Access Compliance Report

Public Rights-of-Way

Intersection ID: N/A	Main Street:	Cross Street: N/A	Location: N/A
ADA ID: 17CF617054E2	Signal Type: Two Push Buttons-Non APS	Overall Compliance: No	Severity Score: BTN 1:N/A BTN 2: N/A No BTN: N/A
Codes/Mitigation Info/Possible Solution		Field Measurements/Component Compliance

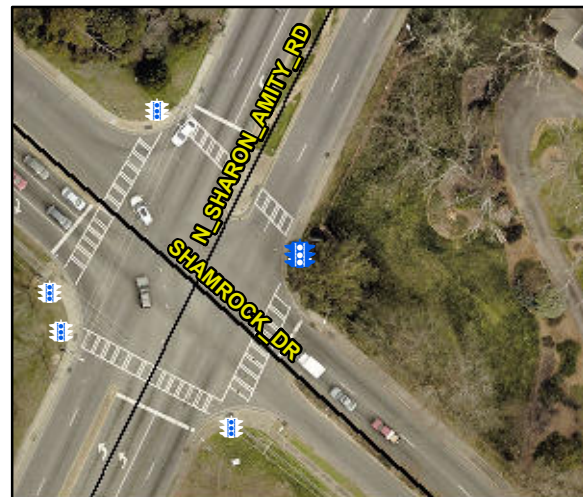
PROW/ADA: TMUTCD 4e.08, R406.2, R404.7.3

Possible Solutions: Replace Signal Push Button With APS Button on New Post. Remove & Relocate Sign.
